SERVICE BULLETIN

MAIN ROTOR HUB INSPECTION

This Bulletin supersedes and cancels SL900-039 dated 20 May 1998.

All McDonnell Douglas Helicopter Systems (MDHS) MD900 helicopters, serial number 900-0002 thru 900-0057.

Figure 1. Main Rotor Upper Hub Assembly Inspection.

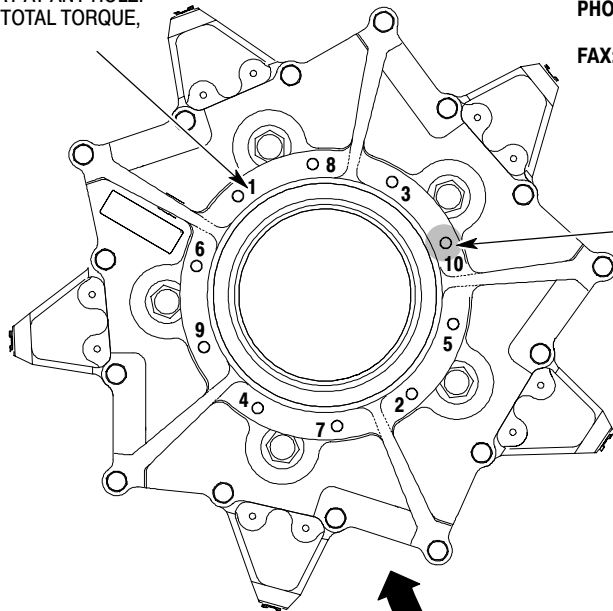
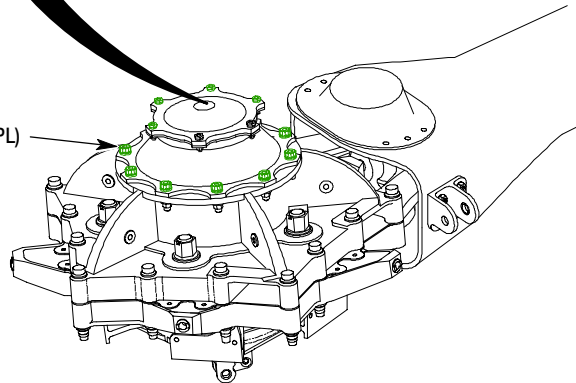
- (1). If present, remove sealant from affected hardware.
- (2). Using an indelible marker, number the main rotor drive plate attachment fastener torque sequence onto the drive plate (Ref. Figure 1).

NOTE: Record aircraft, operator, and torque information on Figure 1. Fax a copy of completed Figure 1 to attention Dale Clay, 602-891-6782.

- (5). Using paint stripper (C313) and cleaning solvent (C420) remove paint from the mating surface of the main rotor upper hub assembly (Ref. CSP-SPM and Figure 1).
- (6). If any paint is present on the lower mating surface of the main rotor drive plate, remove paint (Ref. step (5)).
- (7). Using a 10X magnifying glass, inspect the area around the ten (10) mating fastener holes of the main rotor upper hub assembly for any suspected evidence of cracking. If any crack is verified replace the discrepant parts per the Rotorcraft Maintenance Manual (CSP-900RMM-2, Section 62-20-00).

- (9). Reinstall the main rotor drive plate onto a serviceable main rotor upper hub assembly per the Rotorcraft Maintenance Manual (CSP-900RMM-2, Section 63-10-00). Torque nuts to 160-180 in-lbs (beyond locking torque) in the sequence shown (Ref. Figure 1).

1. MAIN ROTOR DRIVE PLATE ATTACHMENT HARDWARE TORQUE SEQUENCE.
2. NUMBERING MAY START AT ANY HOLE.
3. TORQUE NUTS TO 1/2 TOTAL TORQUE, THEN FULL TORQUE.

AREA AROUND BOLT HOLES TO BE INSPECTED FOR CRACKING (10 PL)
